CONTRACT CHANGE ORDER NO. \_\_\_\_  
SHEET \_\_\_\_ OF \_\_\_\_

**ALTERNATE BARRIER DETAILS -  
CONNECTION BEFORE LOAD TRANSFER**

**SAN FRANCISCO OAKLAND BAY BRIDGE  
EAST SPAN SEISMIC SAFETY PROJECT  
SELF-ANCHORED SUSPENSION BRIDGE  
(SUPERSTRUCTURE & TOWER)  
BARRIER DETAILS NO. 2B**

MARK	DATE	DESCRIPTIONS	BY	CH'D	CCO
Δ	04/05/10	BARRIER MODIFICATIONS	GB	MN	44
		REVISIONS

**FOR LIFTS 1 THROUGH 6: DECK DRILLED FOR DRAINAGE PLATES** (See Note 13)

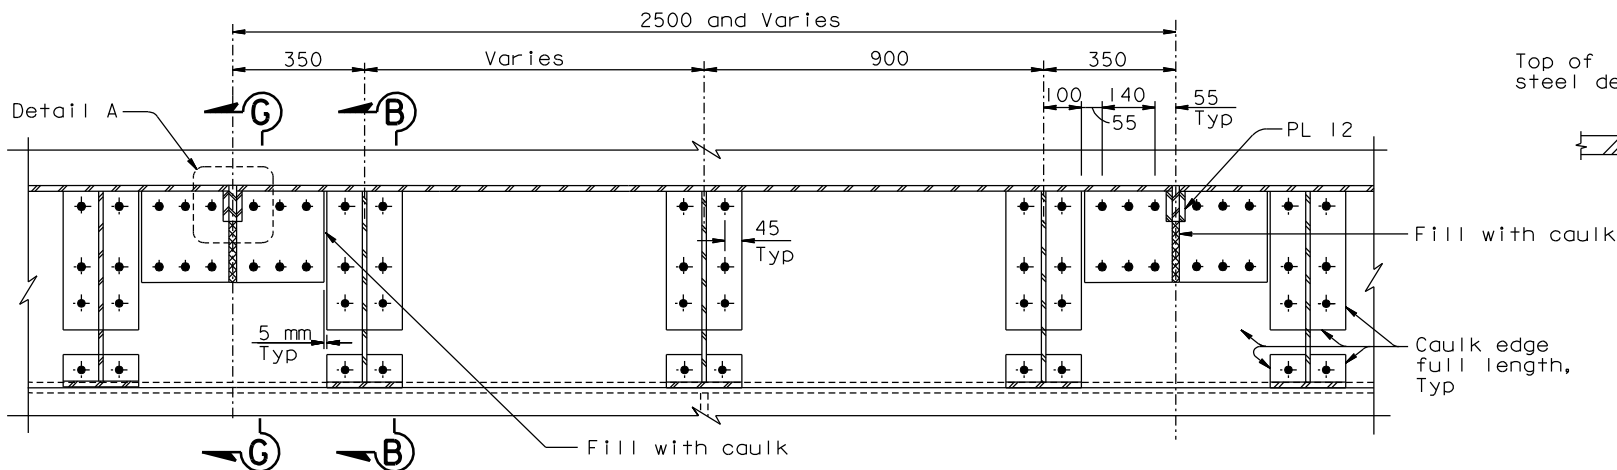
**PLAN-STEEL BARRIER** Type 732 Modified for (W2) (E5)  
1:10

**FOR LIFTS 7 THROUGH 14: DECK NOT DRILLED FOR DRAINAGE PLATES** (See Note 13)

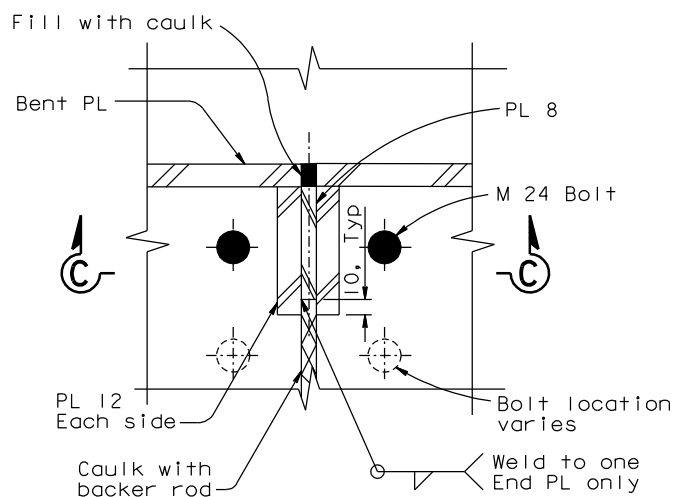
**PLAN-STEEL BARRIER** Type 732 Modified for (W2) (E5)  
1:10

- For Section B-B and Details not shown for Lines W2/E5, see "Barrier Details No. 2".
- Drainage PL 25x319x698 not required. Fill all drilled holes with M22 HS bolts.
